CITY OF YPSILANTI
Planning Commission MEETING
Wednesday, July 20, 2022 @ 7:00 PM
Council Chambers
One South Huron, Ypsilanti, MI 48197

**Staff Review of Special Use and Limited Site Plan
300 W Michigan Ave**

Subject: Preliminary Site Plan Review Comments – 300 W Michigan Ave.

PROJECT	MI-HQ - YPSILANTI	DATE	JUN 27, 2022
SITE PLAN EXHIBIT			106 S. MAIN STREET ANN ARBOR, MICHIGAN 48104

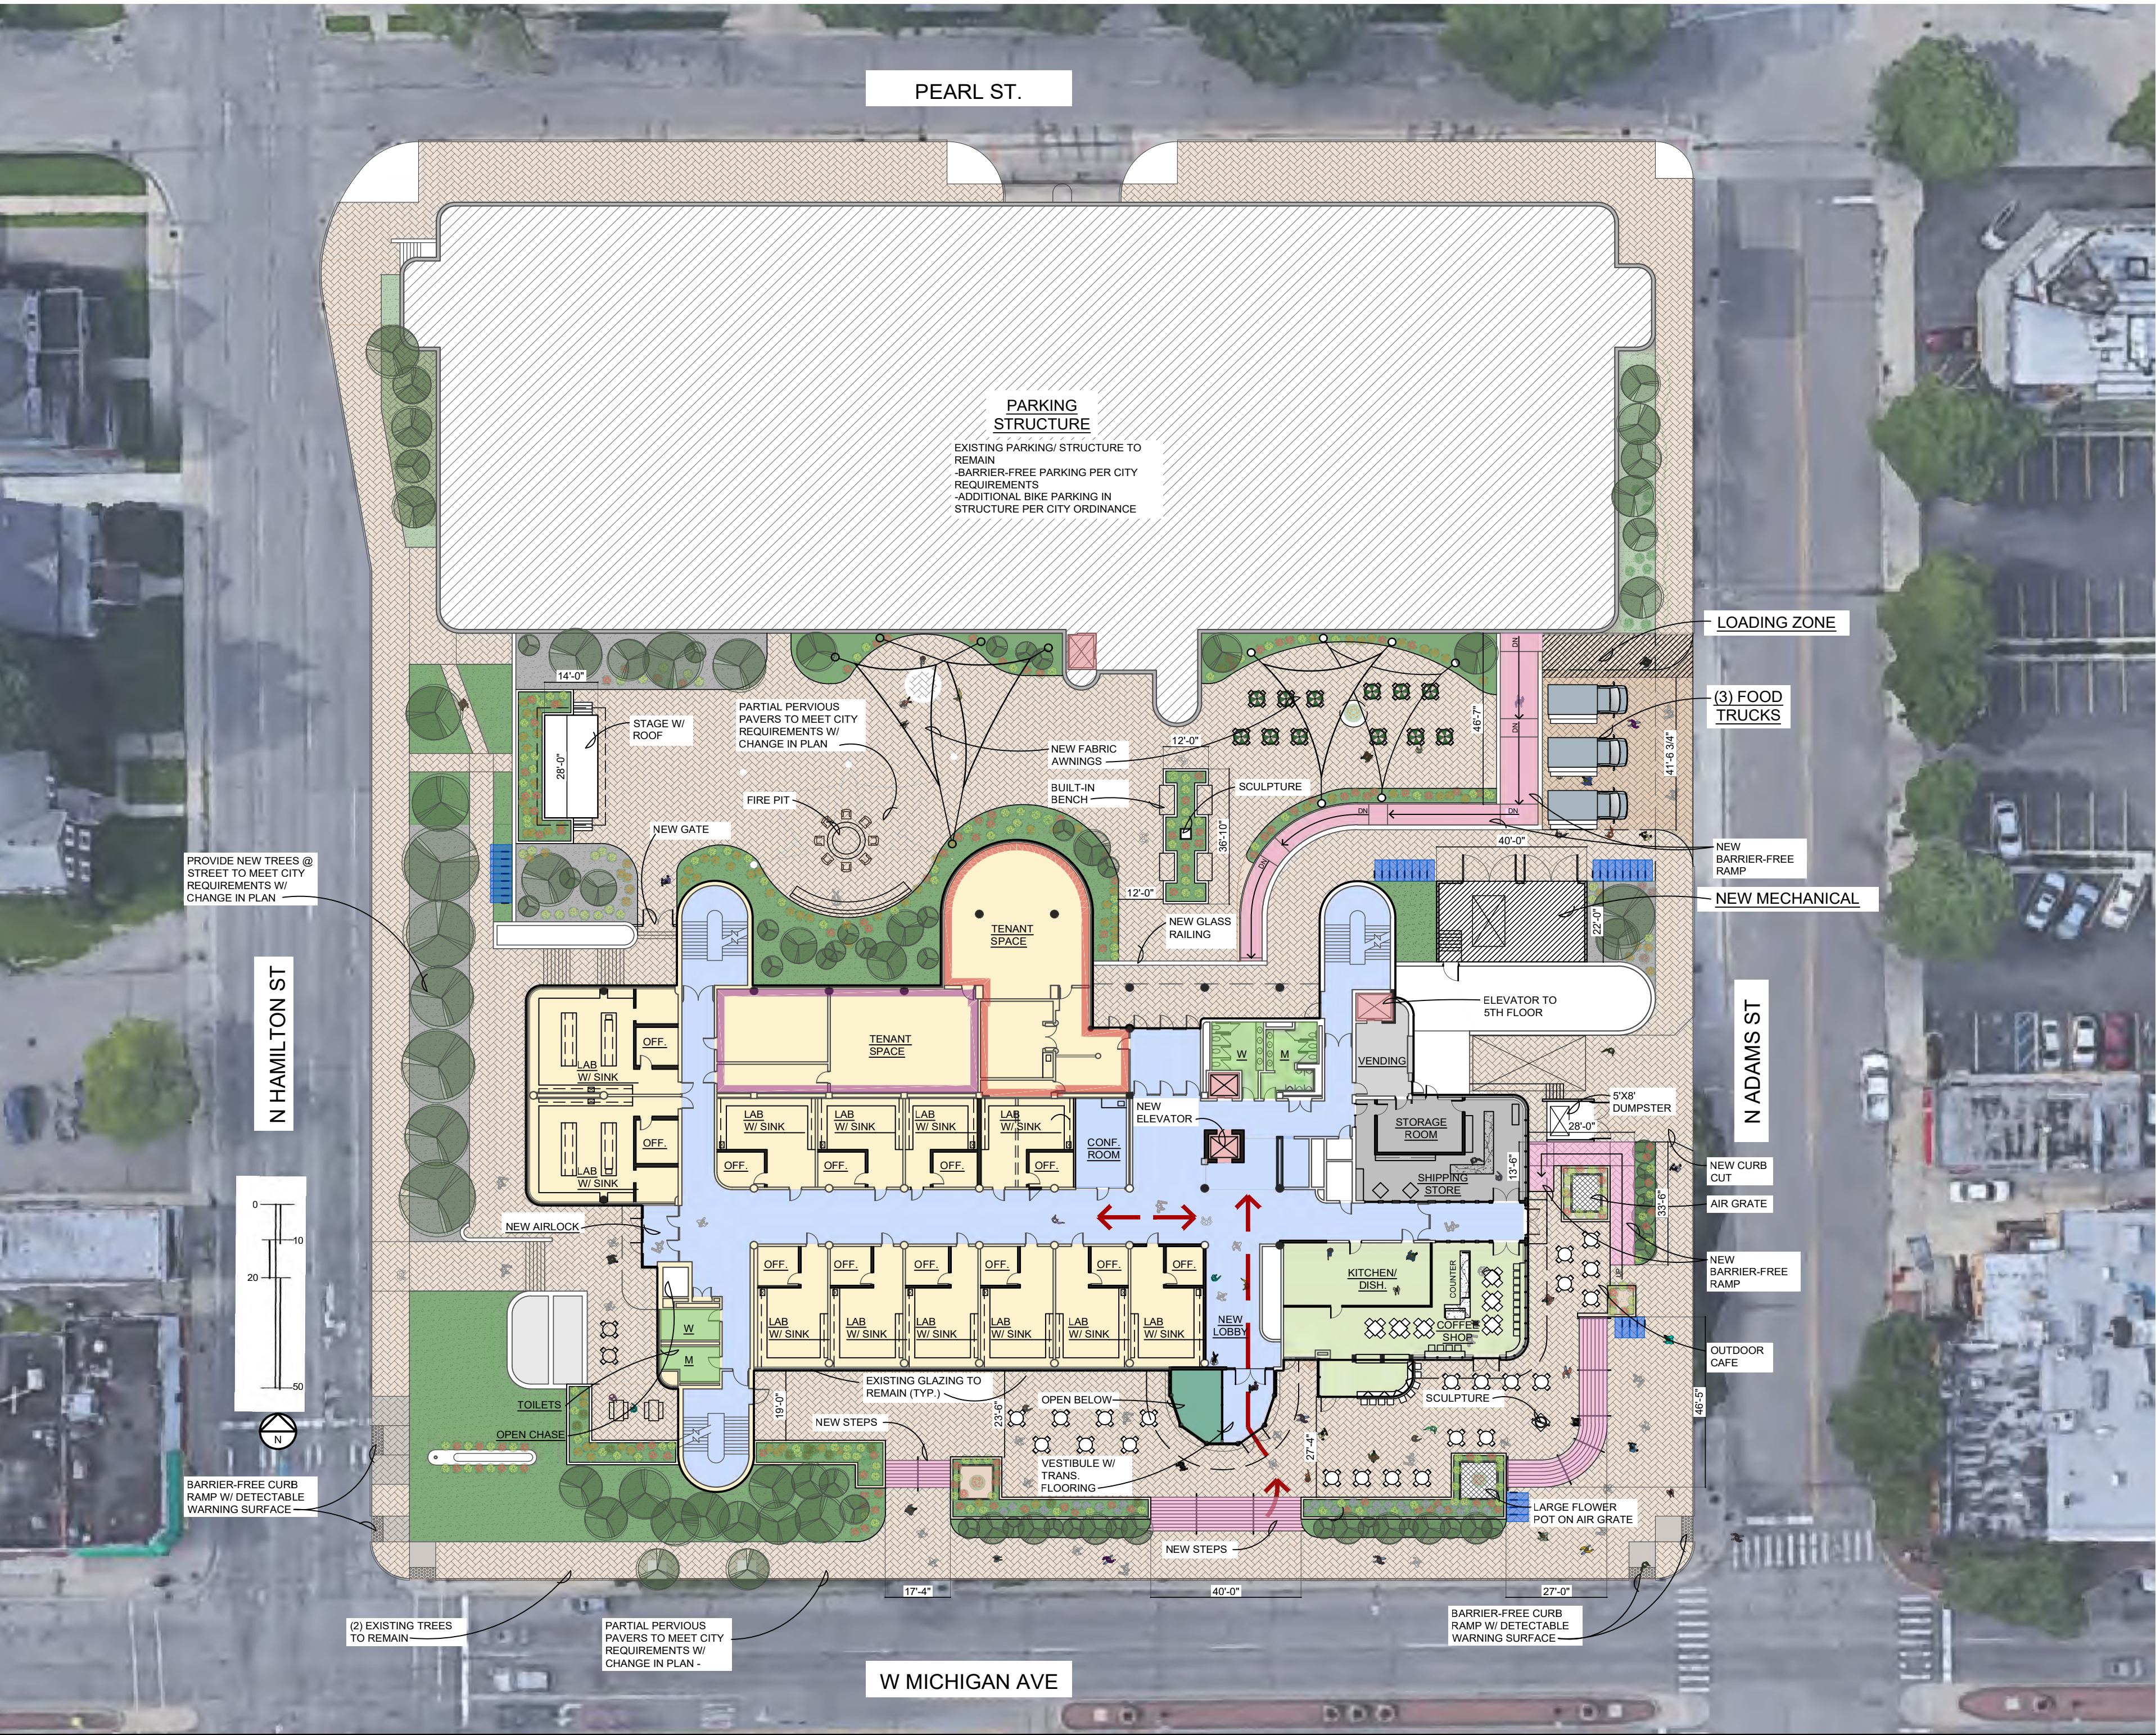
- Curb-cut for food truck area exceeds 30' and shall be reduced per §122-683(b), or removed and the applicant coordinate a mountable curb-cut design with the Department of Public Services (DPS).
- Bicycle parking numbers shall be labeled on site plan.
- Right-of-way work shall be reviewed by MDOT and DPS.

- Applicant provide a lighting plan conforming with the provisions of 122-609.
- Landscaping plan for new landscaping, including plant species and street trees shall be reviewed administratively. Applicant provide a fee-in-lieu for Pearl St if trees cannot be provided, in accordance with 122-636.

5. Curb-cut for food truck area exceeds 30' and shall be reduced per §122-683(b), or removed altogether.
6. Bicycle parking numbers shall be labeled on site plan.

7. Right-of-way work shall be reviewed by MDOT and the City's Department of Public Services.
8. Applicant provide a lighting plan conforming with the provisions of 122-609.

9. Landscaping plan for new landscaping, including plant species and street trees shall be reviewed administratively. Applicant provide a fee-in-lieu for Pearl St if trees cannot be provided, in accordance with 122-636.

Figure 13: Limited Site Plan Capture (detail)

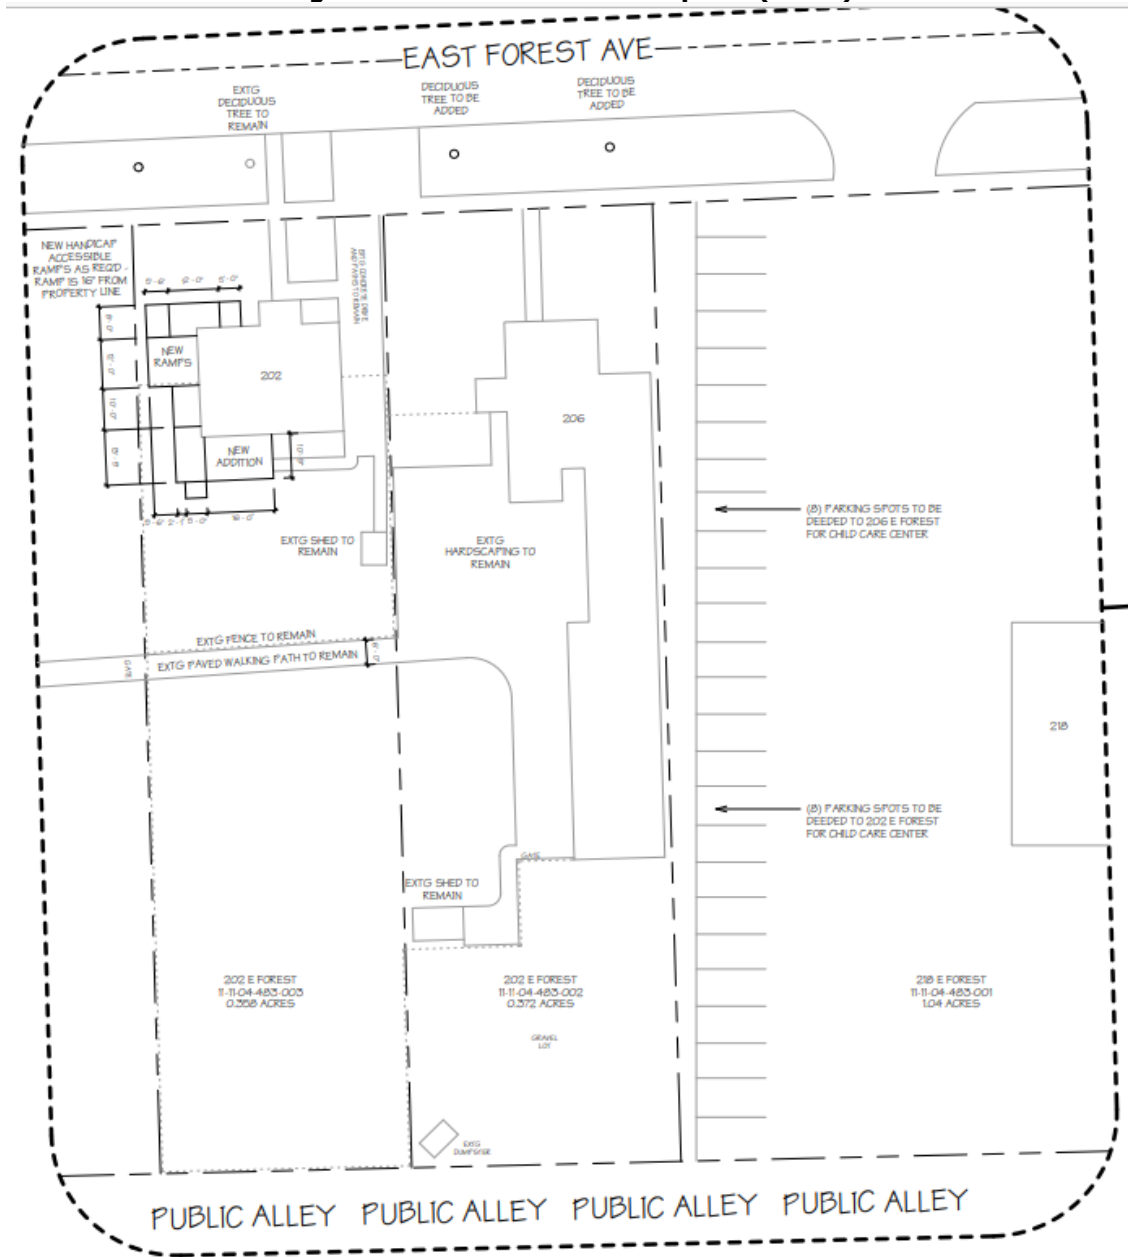
Items to be Addressed: On this site plan, 202 E Forest is listed twice. When the revised site plan is submitted for final review, it should correct that.

SURVEY OF EXISTING CONDITIONS & REMOVAL PLAN FOR:
401 E MICHIGAN AVENUE
YPSILANTI, MI 48198
PART OF THE NORTHEAST 1/4, SECTION 9,
T3S-R7E, CITY OF YPSILANTI, WASHTENAW COUNTY, MICHIGAN

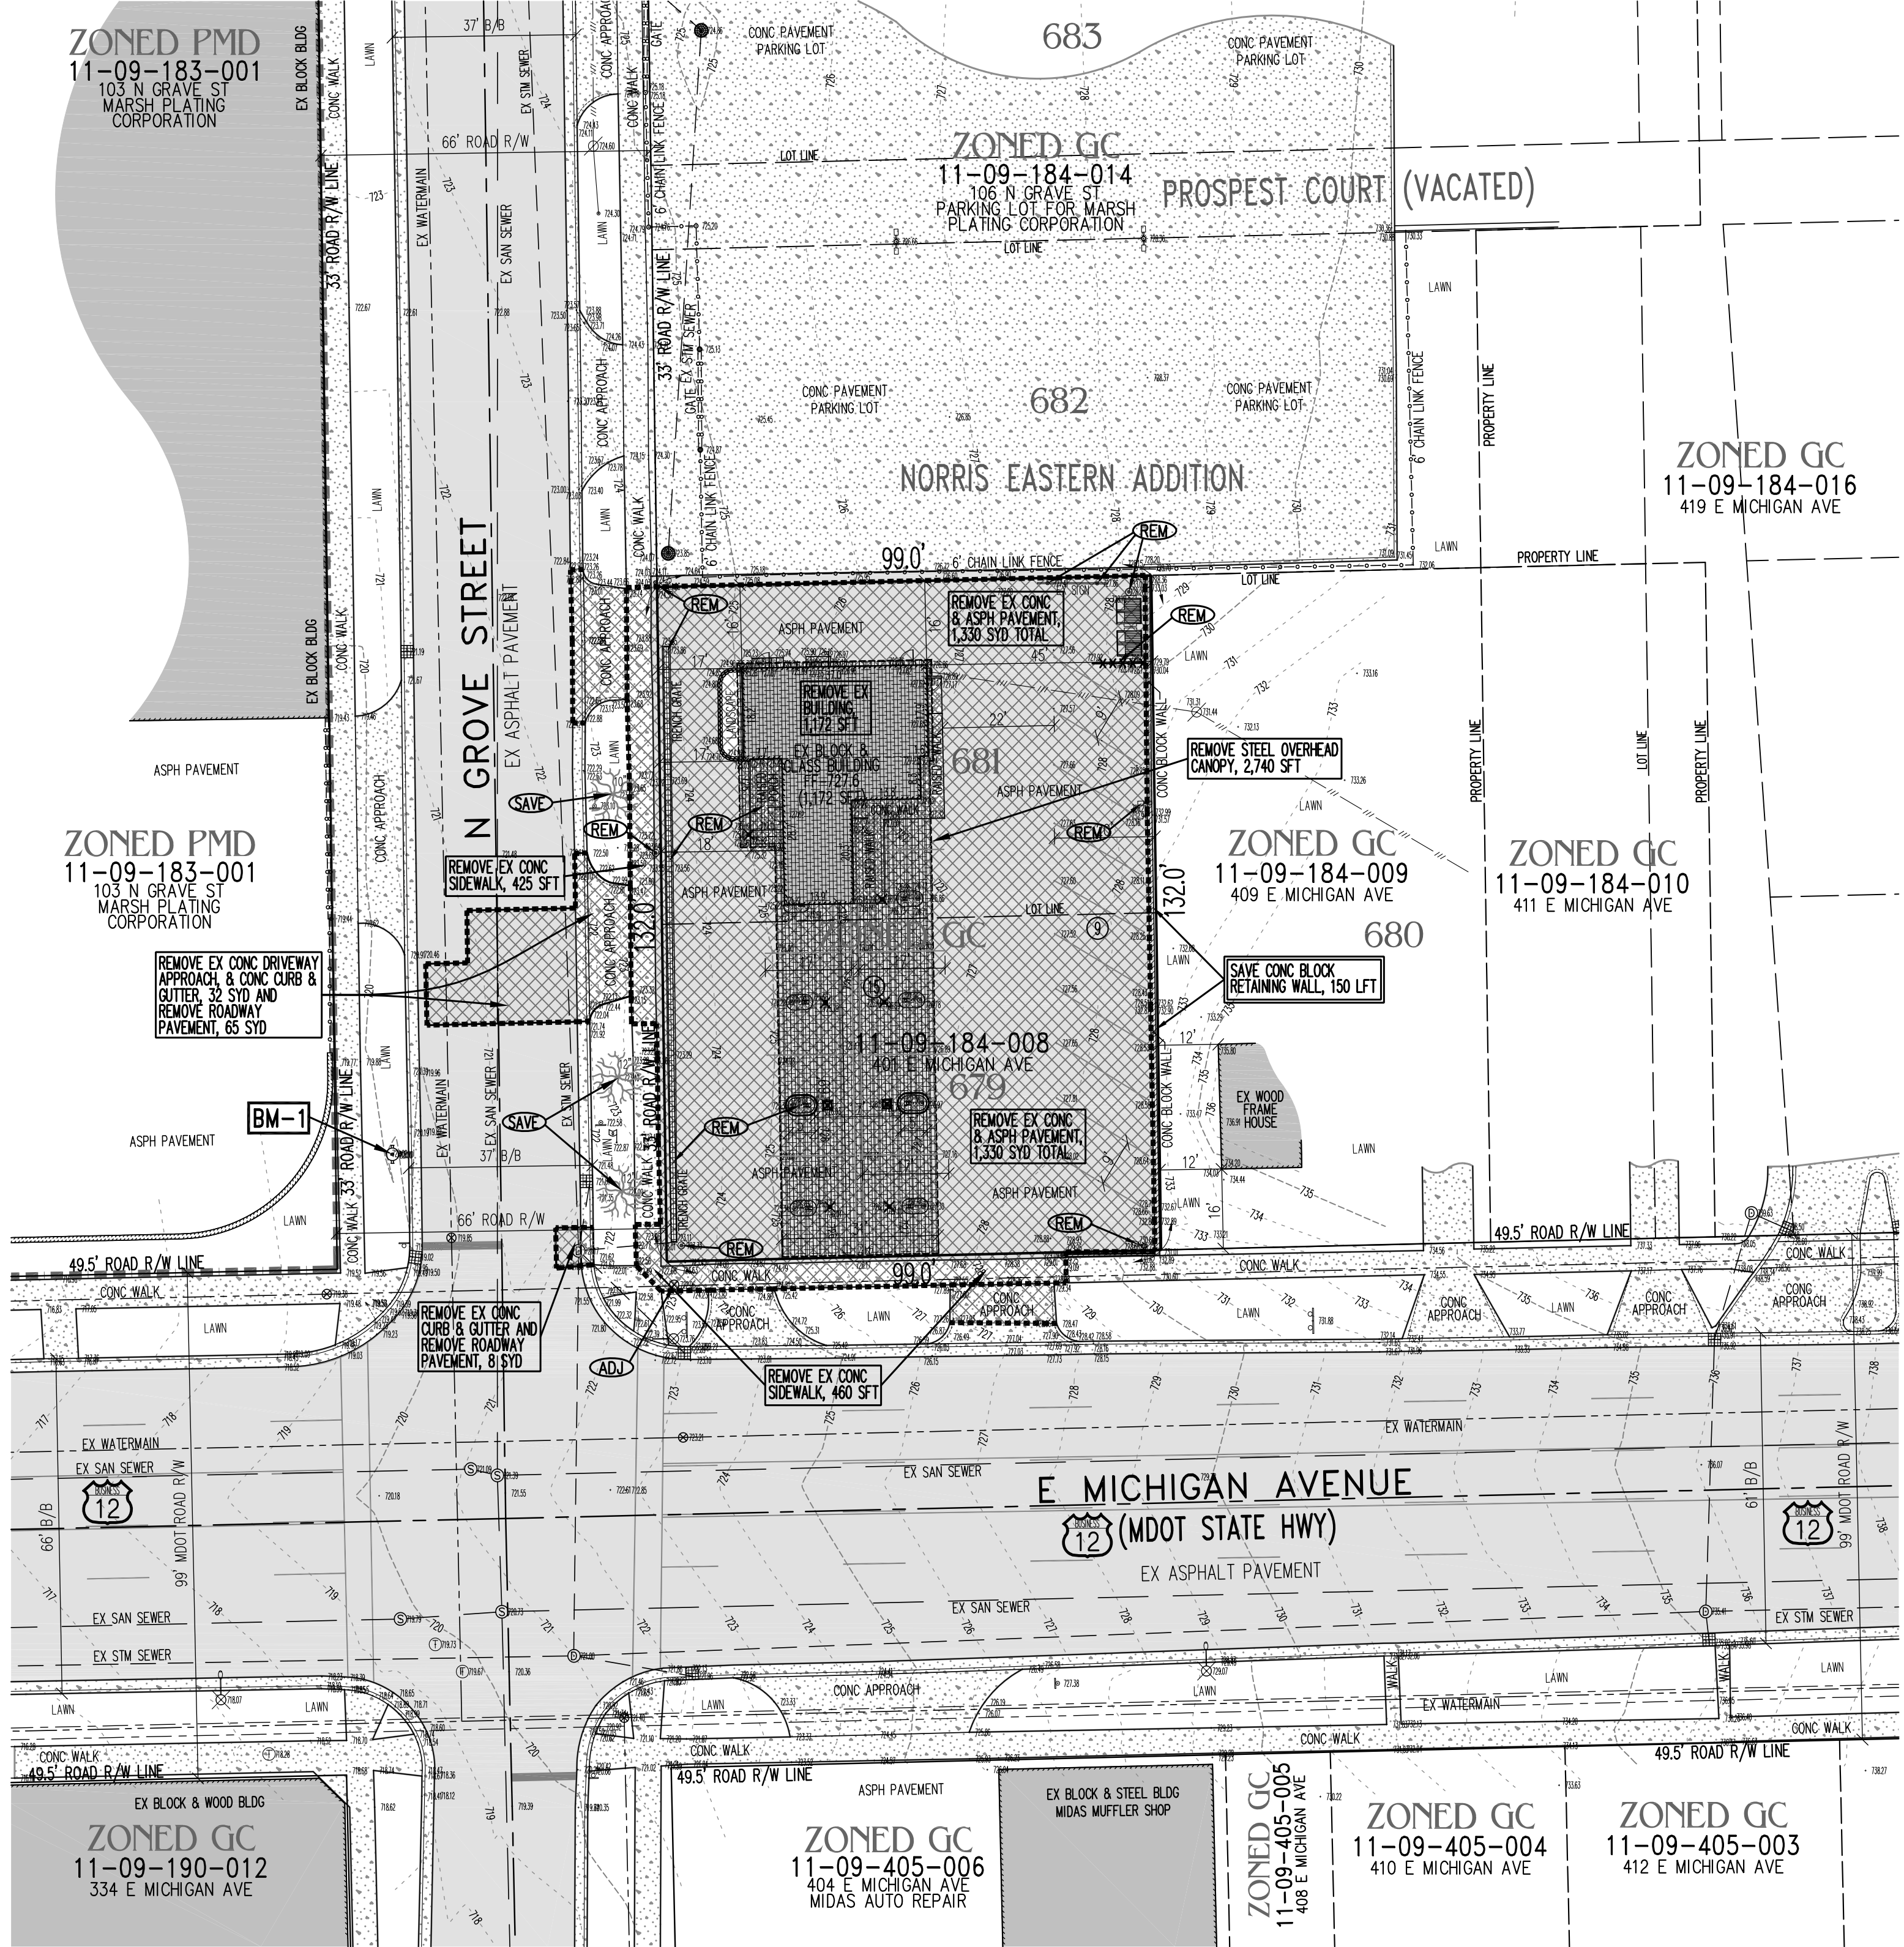
12. Proposed work within the Michigan Avenue Right-of-Way will require a permit from the Michigan Department of Transportation (MDOT).
13. Existing water and sanitary services should be shown on sheet C-2 Survey of Existing Conditions & Removal Plan. Review and approval for the water and sanitary work will be required from the Ypsilanti Communities Utility Authority (YCUA). The applicant should coordinate with YCUA regarding the water and sanitary service(s).
